**Grid Code
Modification
Recommendation Form**

Title of Recommended Proposal: MPID 327 DSU Notice to React

MPID: 327

Date:	17/02/2025
Recommended at GCRP Meeting No.:	GCRP Meeting 24/09/2024
Grid Code Version:	Version 14.2
Grid Code Section(s) Impacted by Recommended Proposal:	SDC2 and definitions

Red line = Declared availability , Green Line = Dispatch Instruction and Yellow line = DSU Response

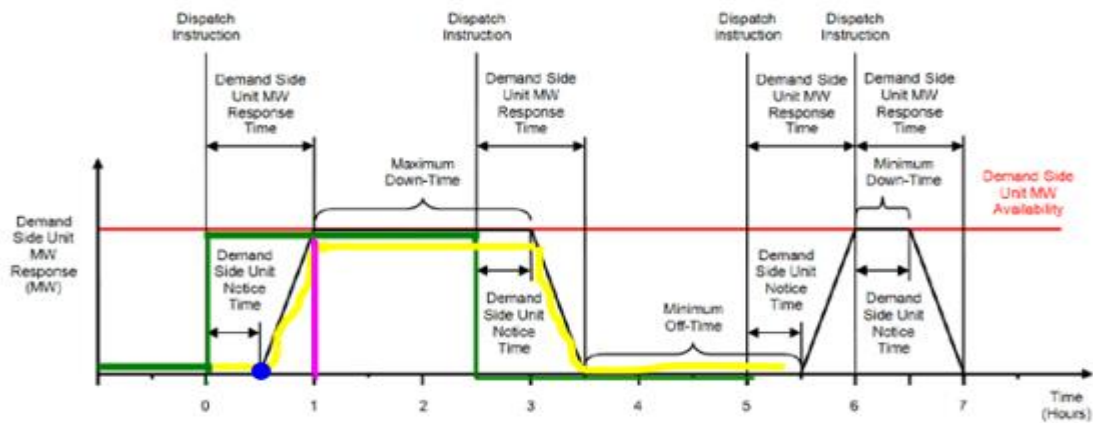
In summary, the TSO discussed MPID327 Notice to React (blue mark) and and the DSU representatives proposed to consider a different measure (pink mark). The diagram below illustrates these:

DSU Grid Code Requirements	Trigger	Notice Time	Ramping Time	@ End of MW Response Time
● MPID 327 Notice to React	Plus 15mins deadband to initiate a response	✓	✓	N/A to this mod 100% is existing obligation
● DSU proposal	At end of DSU MW Response Time	✗	✗	Any response

During the JGCRP and GCRP meetings, the DSU representatives stated that they are broadly in favour of the proposed modification but suggested that the “Failure to Follow Notice to React” should be applied after the end of the **Demand Side Unit MW Response Time**, which is the sum of the **Demand Side Unit Notice Time** and the **Demand Side Unit Ramping Time**. This suggestion by the DSU representatives is further described later in this recommendation paper as DSU proposal.

Following this assessment, the TSO cannot support the option proposed by the DSU representatives, as alternative to MPID327 – Notice to React and have explained measures required to be taken by some DSU’s to be Grid code compliant based on existing obligations following examination of DSU sample dispatches presented by the TSO and DSU representatives. Being Grid code compliant to existing obligations would remove the need for DSU representatives to propose alternate modification proposals.
